Access Compliance Report

Public Rights-of-Way

(Curb Ramps)

Intersection ID: 20407	Main Street: CAMERON_VALLEY_PY	Cross Street: COLTSGATE_RD	Location: E
ADA ID: EAE631825713	Ramp Type: PerpDiag	Initial Pass/Fail: Fail	Overall Compliance: No
		Severity Score: 8.75

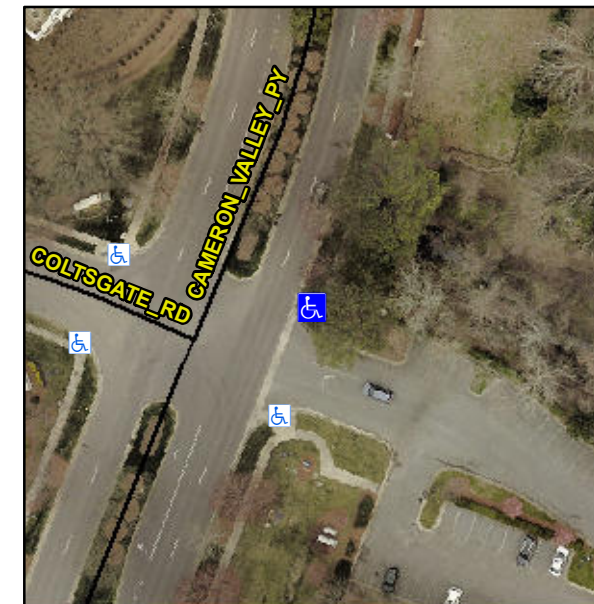
R304.5.1

Compliance	Description	Data	Compliance	Description	Data
N/A	Ramp Length (in)	58.0	Yes	Ramp Slope (%)	7.5
No	Ramp Width (in)	38.0	Yes	Ramp XSlope (%)	0.4
N/A	Flare Type LT	N/A	N/A	Flare Type RT	N/A
N/A	Flare Slope LT (%)	N/A	N/A	Flare Slope RT (%)	N/A
N/A	Flare Traversable LT?	N/A	N/A	Flare Traversable RT?	N/A
N/A	Landing Length (in)	N/A	N/A	DWS Provided?	N/A
N/A	Landing Width (in)	N/A	N/A	DWS Contrast?	N/A
N/A	Landing Slope (%)	N/A	N/A	DWS Length (in)	N/A
N/A	Landing X Slope (%)	N/A	N/A	DWS Full Width?	N/A
N/A	Landing Curb? (Y/N)	N/A	N/A	DWS Offset (in)	N/A
N/A	Shared Landing?	N/A			
N/A	Gutter Ponding?	N/A	N/A	Gutter Slope (%)	N/A
N/A	Gutter Lip Ht (in)	N/A	N/A	Gutter X Slope (%)	N/A
N/A	Painted X Walk1?	No	N/A	Painted X Walk2?	No
	X Walk 1 Direction	To NW		X Walk 2 Direction	To SW
N/A	X Walk 1 Width (in)	N/A	N/A	X Walk 2 Width (in)	N/A
	X Walk 1 Slope (%)	2.4		X Walk 2 Slope (%)	0.3
	X Walk 1 X Slope (%)	0.2		X Walk 2 X Slope (%)	1.6

Remove & Replace Curb Ramp With Two New Directional Ramps or Equivalent.
